REMARKS

Docket Number: 45,605
U.S. Serial Number: 08/468,649

FIG. 16 (Prior Art)

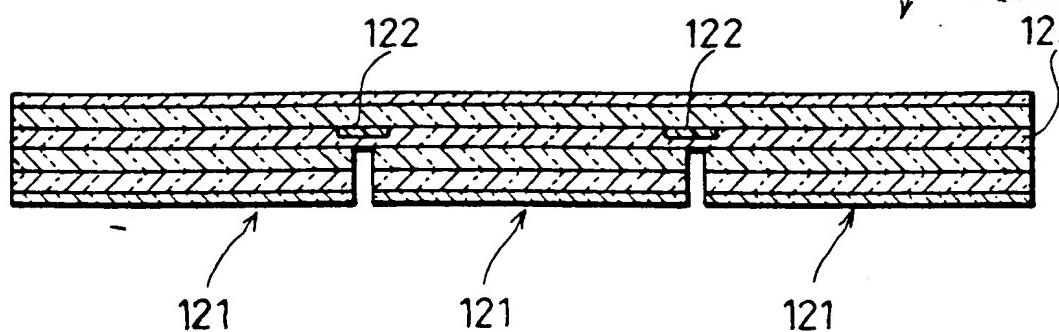
In the Official Action dated March 22, 1996, the Examiner objected to Figures 15-18 as not being designated by a legend such as "Prior Art." Substitute Figures 15-18 are submitted herewith having changes in red for the Examiner's approval.
